Access Compliance Report

Public Rights-of-Way

(Curb Ramps)

Intersection ID: 7488	Main Street: LOG_CABIN_RD	Cross Street: MT_KISCO_DR	Location: S
ADA ID: 7C378A84D9FF	Ramp Type: BlendTrans1	Initial Pass/Fail: Fail	Overall Compliance: No
Codes/Mitigation Info/Possible Solution			Severity Score: 10
			Field Measurements/Component Compliance

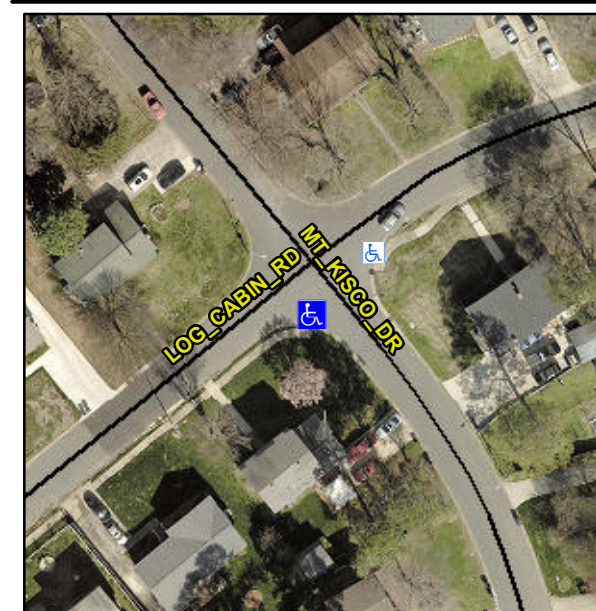
NO LT SW

Not Found, R304.5.1, R304.5.3

Compliance	Description	Data	Compliance	Description	Data
N/A	Ramp Length (in)	74.0	Yes	BlendTrans Slope (%)	4.3
No	Ramp Width (in)	38.0	No	BlendTrans XSlope (%)	3.1
N/A	Flare Type LT	N/A	N/A	Flare Type RT	N/A
N/A	Flare Slope LT (%)	N/A	N/A	Flare Slope RT (%)	N/A
N/A	Flare Traversable LT?	N/A	N/A	Flare Traversable RT?	N/A
N/A	Landing Length (in)	N/A	N/A	DWS Provided?	N/A
N/A	Landing Width (in)	N/A	N/A	DWS Contrast?	N/A
N/A	Landing Slope (%)	N/A	N/A	DWS Length (in)	N/A
N/A	Landing X Slope (%)	N/A	N/A	DWS Full Width?	N/A
N/A	Landing Curb? (Y/N)	N/A	N/A	DWS Offset (in)	N/A
N/A	Shared Landing?	N/A			
N/A	Gutter Ponding?	N/A	N/A	Gutter Slope (%)	N/A
N/A	Gutter Lip Ht (in)	N/A	N/A	Gutter X Slope (%)	N/A
N/A	Painted X Walk1?	No	N/A	Painted X Walk2?	N/A
	X Walk 1 Direction	To NE		X Walk 2 Direction	N/A
	X Walk 1 Width (in)	N/A		X Walk 2 Width (in)	N/A
	X Walk 1 Slope (%)	5.9		X Walk 2 Slope (%)	N/A
	X Walk 1 X Slope (%)	0.8		X Walk 2 X Slope (%)	N/A

N/A	Ramp inside XWalk1?	N/A	N/A	Ramp inside XWalk2?	N/A
	Road Slope (%)	0.8		Clear Space?	N/A
	Road X Slope (%)	5.9	N/A	Clear Space to XWalk (in)	N/A
N/A	Any Obstructions?	N/A	N/A	Storm Grate/Utility Hazard?	N/A
	Obstruction Type			Storm Grate/Utility Type	
		N/A			N/A
			Yes	Surface Condition? (G/P)	Good
			No	Curb Slope (%)	12.0

Remove & Replace Curb Ramp With Two New Directional Ramps or Equivalent.
